Subject: **Response to NRC Request for Additional Information Letter No. 397 Related to ESBWR Design Certification Application – Engineered Safety Systems – RAI Numbers 6.4-24 and 6.4-25**

**Response to NRC Request for
Additional Information Letter No. 397
Related to ESBWR Design Certification Application
Engineered Safety Systems
RAI Numbers 6.4-24 and 6.4-25**

NRC RAI 6.4-24

NRC RAI 6.4-25

Figure 1. Case L-2 daily profile

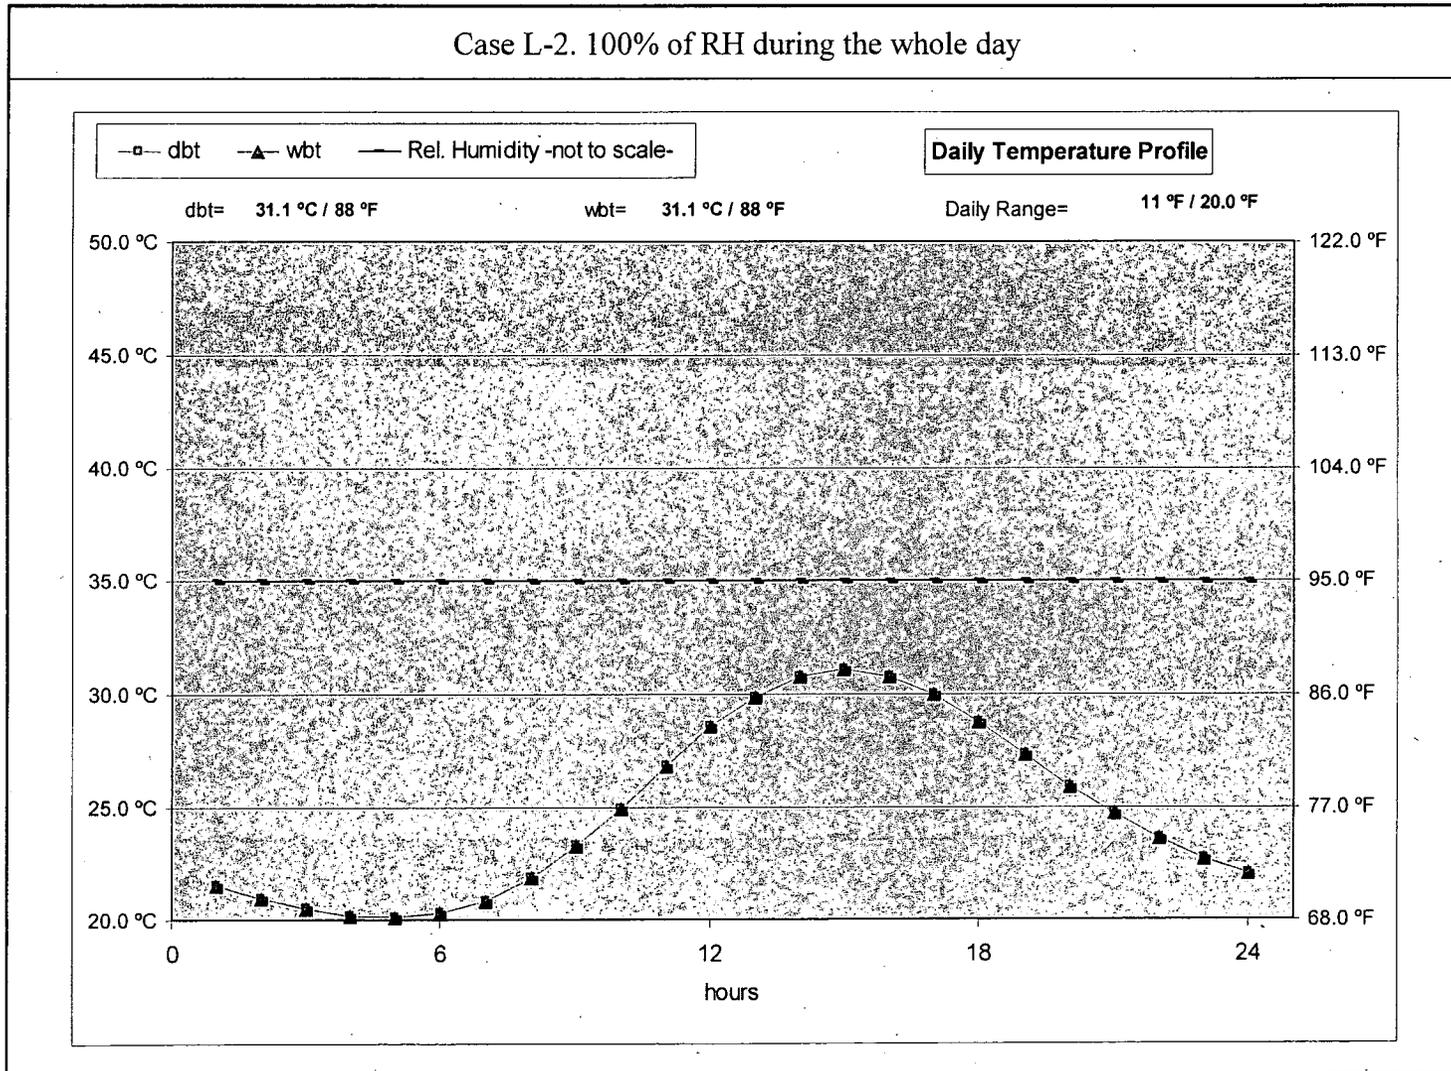
2. Demonstrate there are no environmental dry bulb/humidity combinations within the ESBWR standard plant parameter envelope that would result in greater than 86°F Wet Bulb or Wet Bulb Globe Temperature Index in the CRHA anytime during the 72 hour period of passive cooling. This can be done by providing the input assumptions and results of sensitivity studies using various outside air humidity ranges and diurnal temperature swings, and the same methodology as that proposed for the design basis CRHA heat up calculation.

3. *In the response to #1 above, address the 0 percent exceedance 88°F wet bulb (non-coincident) ambient design temperature value listed in DCD chapter 2 Table 2.01. The proposed ESBWR standard plant site parameter envelope outside air environmental conditions of 88°F wet bulb could result in control room conditions exceeding a heat stress index that uses 86°F wet bulb. Coincident dry bulb temperatures for this wet bulb temperature from 88 degrees to below 117°F are within the proposed ESBWR site parameter envelope. The corresponding relative humidity for this temperature range would be 100 percent to 30 percent. Since the EFUs are designed to exchange the CRHA air 7 to 9 times per day, the staff believes that over time the CRHA relative humidity would trend toward that of the incoming air. Therefore outside air of high temperature and high humidity, when cooled by passive heat sinks in the CHRA could result in increasing humidity in the CRHA at the end of the 72 hour period. Unless moisture is removed, the resultant CHRA heat stress index could be exceeded.*

The heat load due to 200 l/s (Ref-1) outside air intake is taken into account in the CRHA heat up calculations. The outside air dry bulb maximum temperature is 31.1°C (88°F), (Ref-2) and a typical daily temperature range of 11.0°C (20°F) is considered. Due to the 100% humidity condition, the outside air wet bulb maximum temperature is 31.1°C (88°F) as well.

The input design profile data is shown in Fig 1.

Case L-2 (see Table 7 for further information). Design outside air conditions: 31.1°C (88°F), 100% RH and daily range [11°C (20°F)].
